Delegation of the European Union to Bosnia and Herzegovina

Clarification No.1 to the Tender Dossier
Common Information System for Vetting and Issuing of Security Clearances
Bosnia and Herzegovina
Publication reference: EuropeAid/140099/DH/SUP/BA; Tender no: EC/BIH/16/020

Picture no.1:

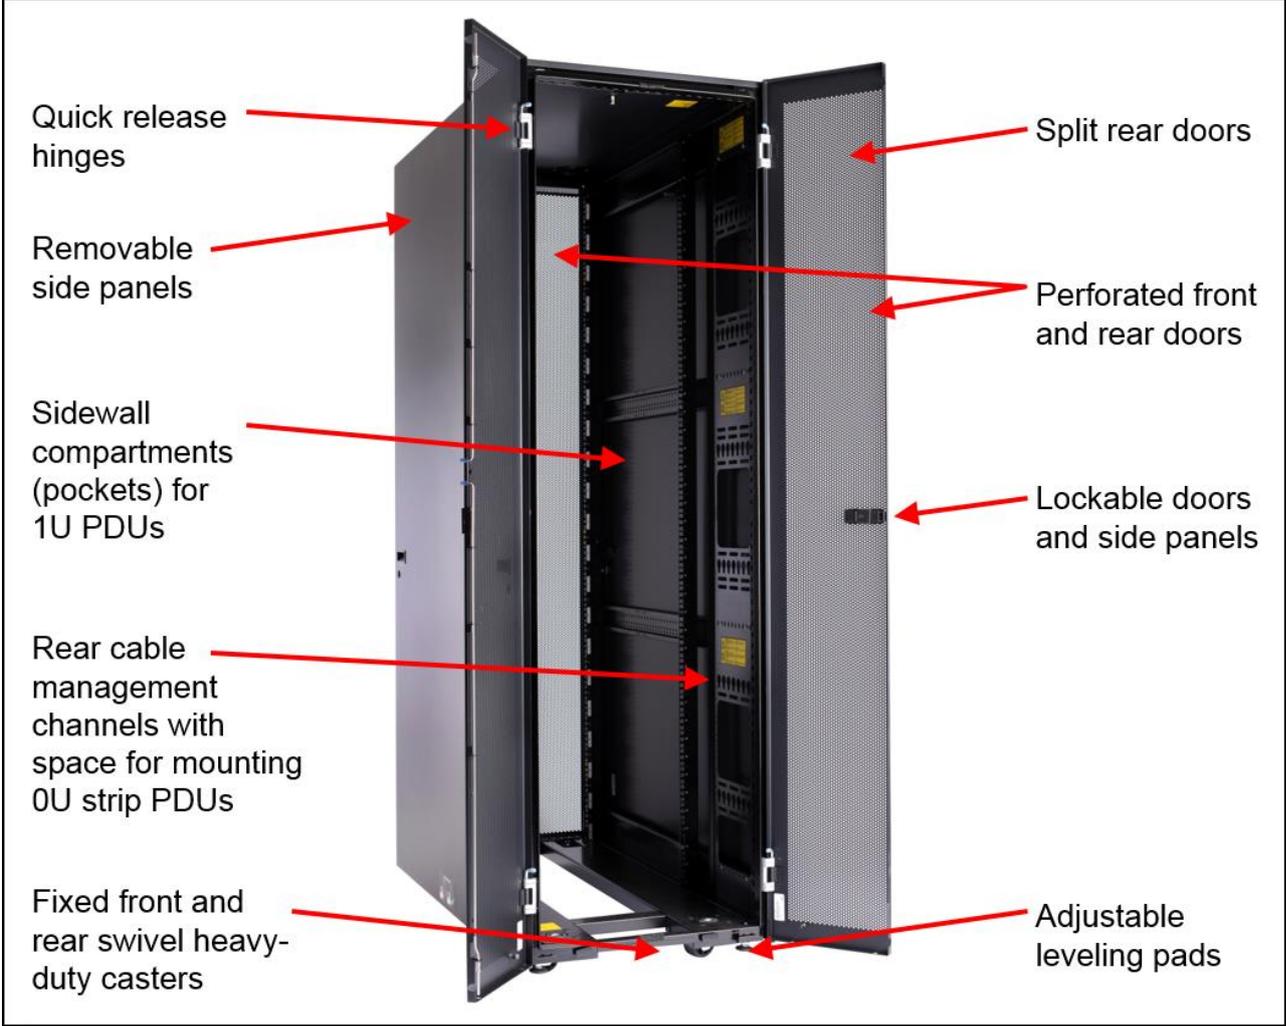
Please explain "Rear cable management channels with space for mounting 0U strip PDUs" in more detail or remove this request.

Please see picture no1. It shows how to include rear channels for cables management with additional space to mount vertical PDU strip as shown on picture no 2 (Answer 16.5).
